Draft - ACTION OF THE PLANNING COMMISSION

ACTION: Following a public hearing conducted on ______, 2018, the Planning Commission approved the Design Review Permit for the Phase 4 Axel project with the attached Findings and Conditions of Approval.

File Number: 178-067-DR

NEW LIGHT-INDUSTRIAL BUILDINGS FOR AXEL PROPERTIES - PHASE IV DEVELOPMENT

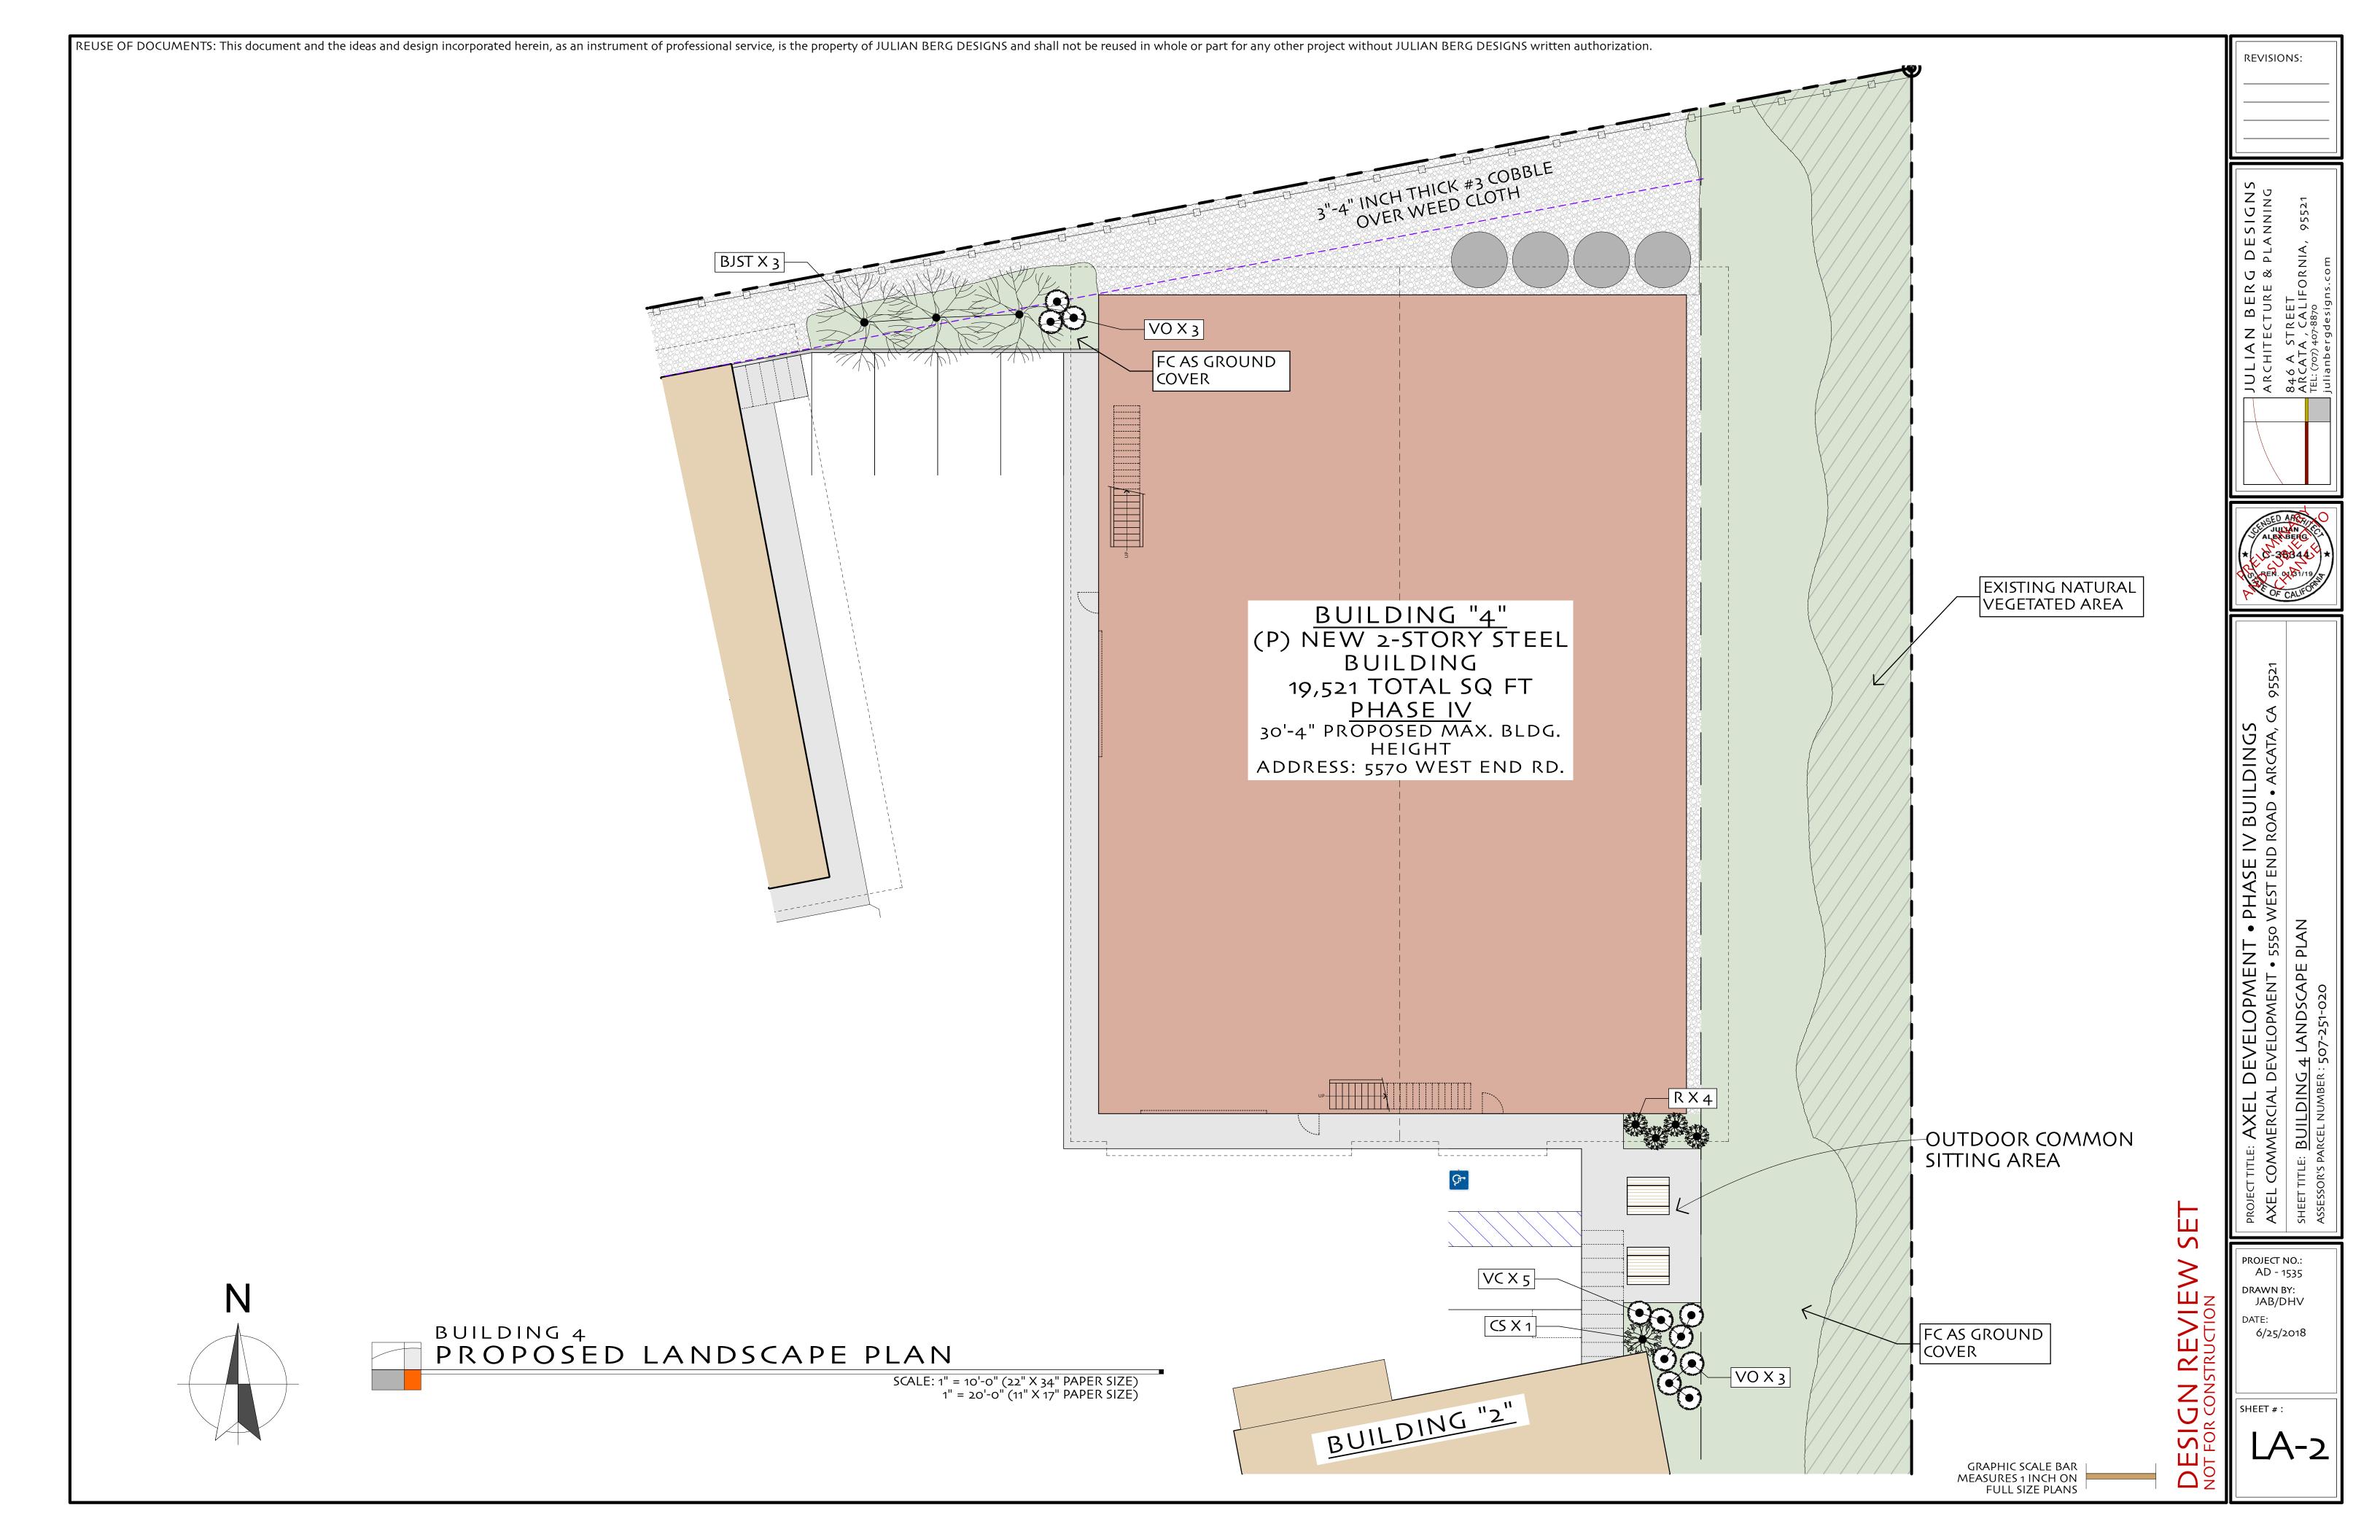
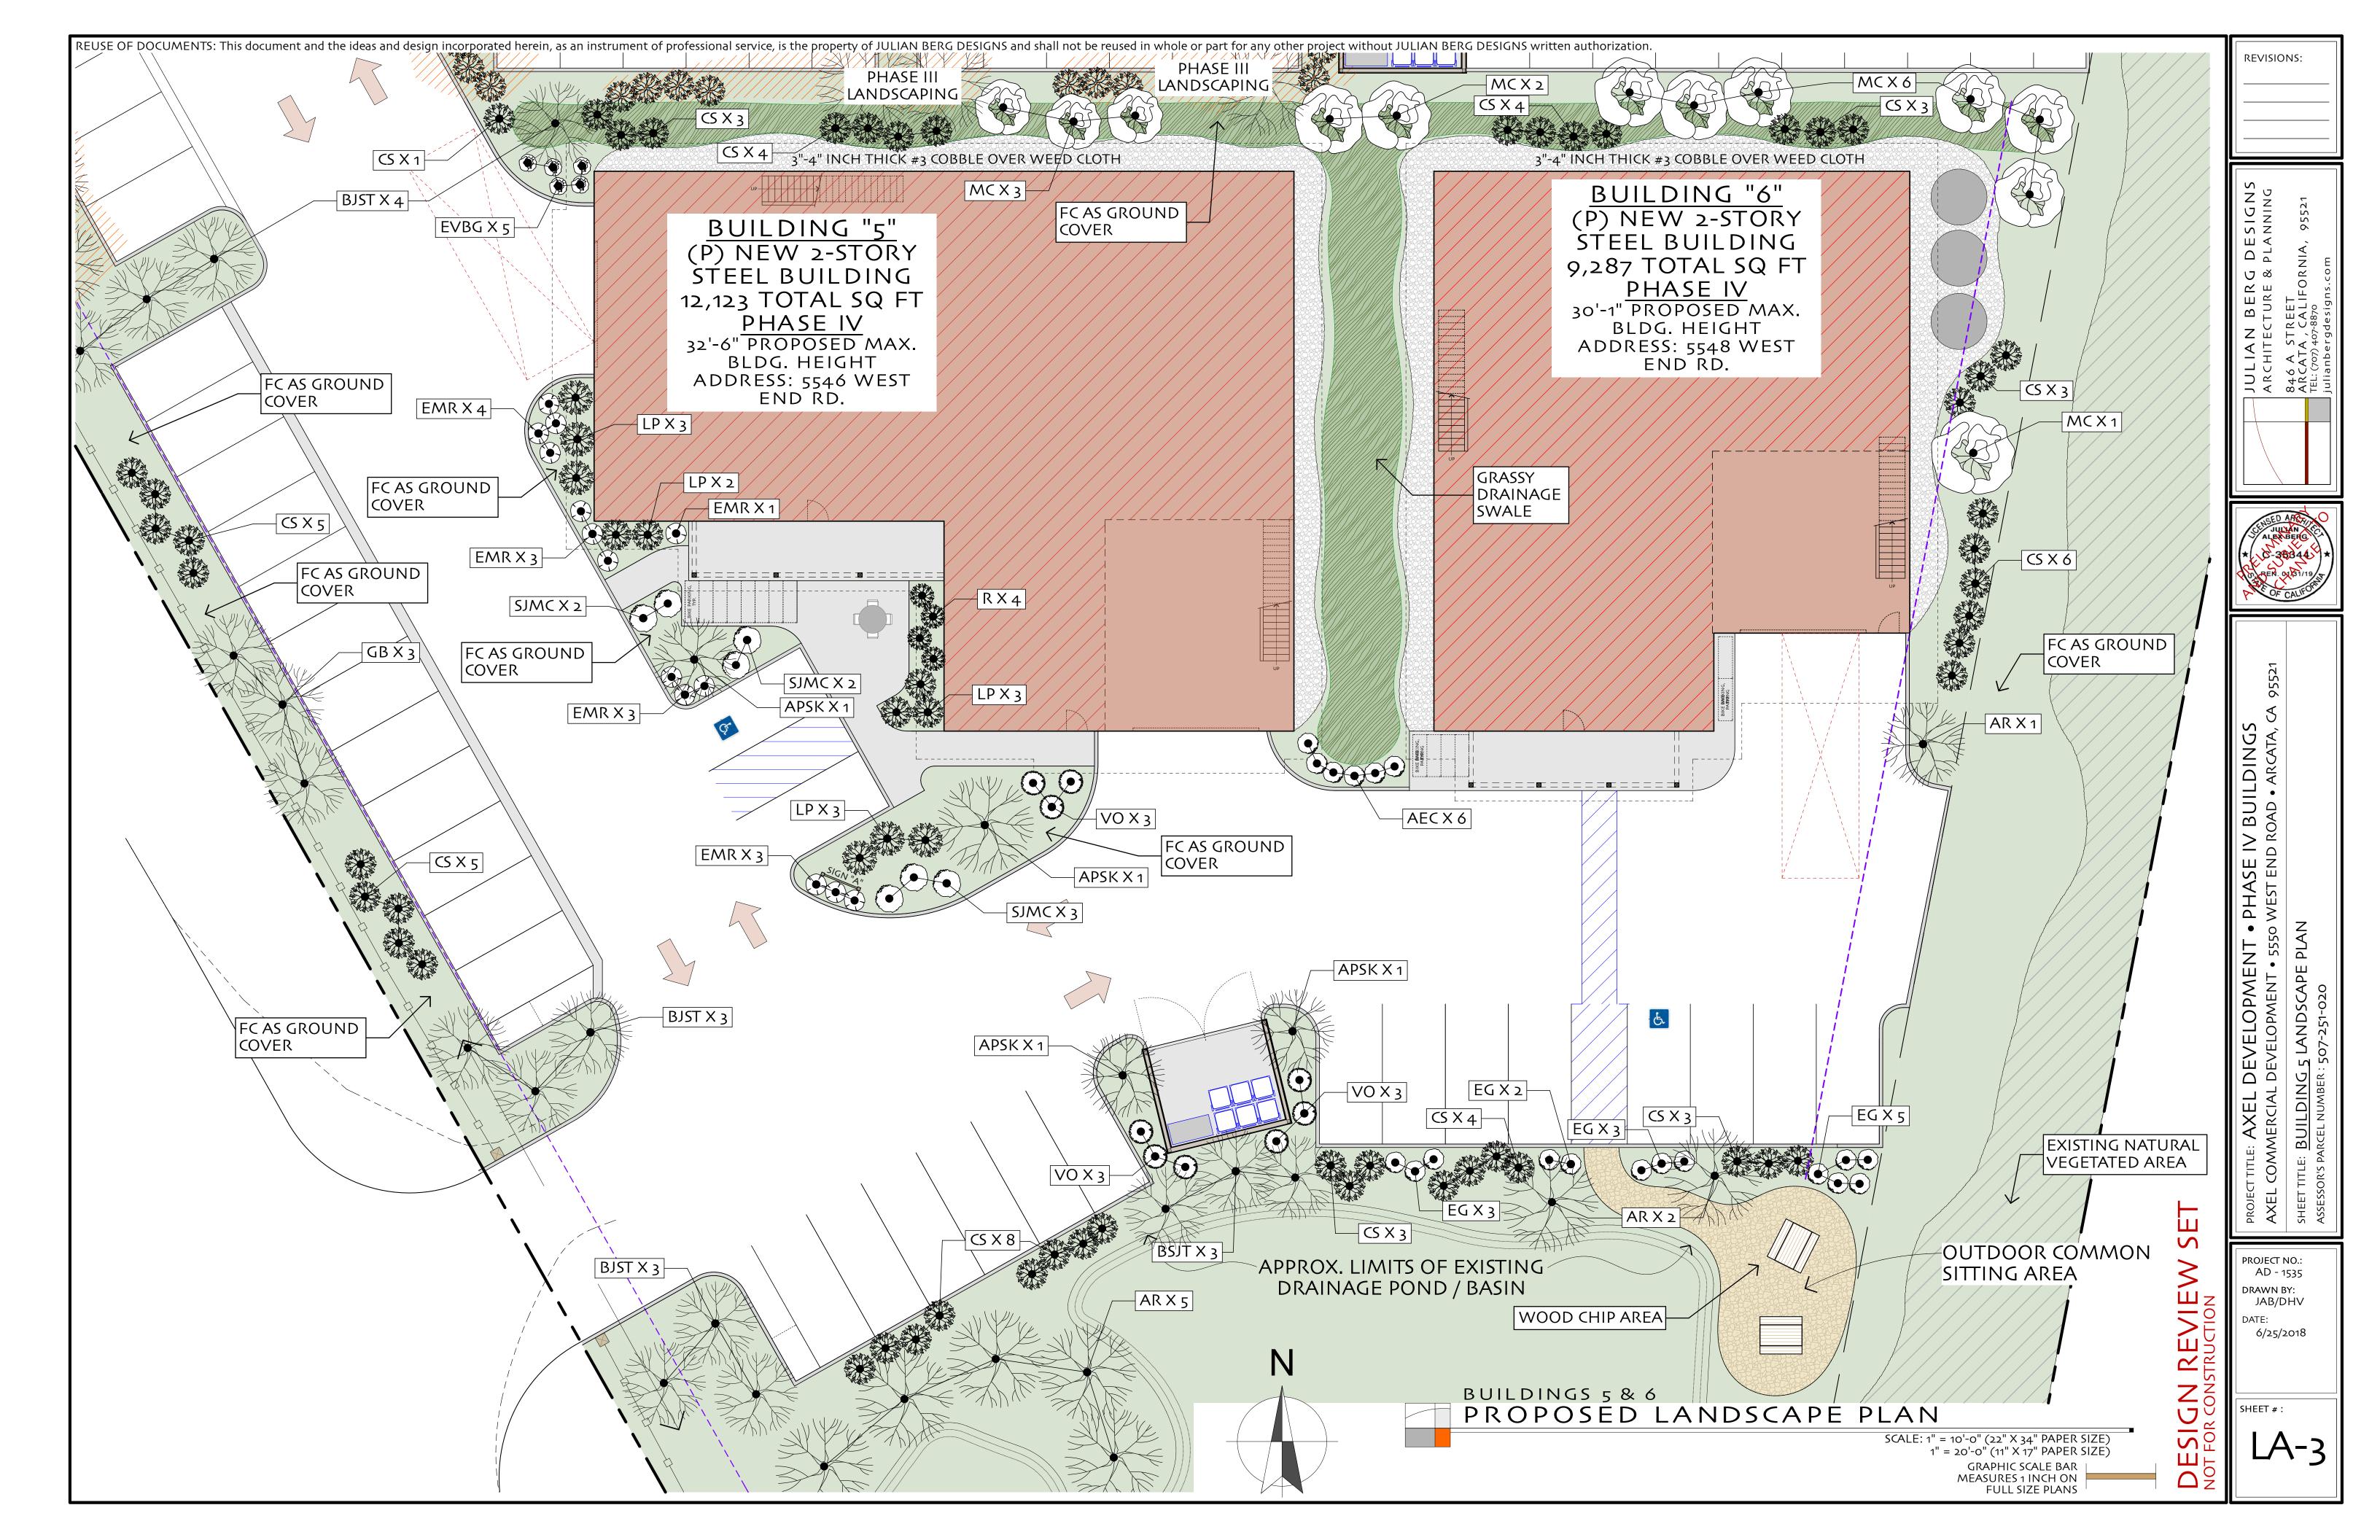
- b. Landscape Plan.
 - i. PG&E. Trees and shrubs shall be located outside the PG&E's easement. Delete the two, *Betula jaquemontii* (Himalayan Birch) trees shown on plans near Building 4 adjacent to the or substitute with small shrubs or plants.

- ii. HBMWD. No large stature trees or shrubs shall be planted within the HBMWD easement. Herbaceous vegetation and small shrubs shall be shown in the landscaping within the easement where provided.

- iv. Replace *Acer palmatum* (Japanese Maple) trees located in exposed or windy locations with *Acer circinatum* (Vine Maple) or other hardy tree species. Eliminate the *Alnus rubra* (Red Alder) tree located at the southeast corner of Building 6 and HBMWD's easement or replace with small shrub.
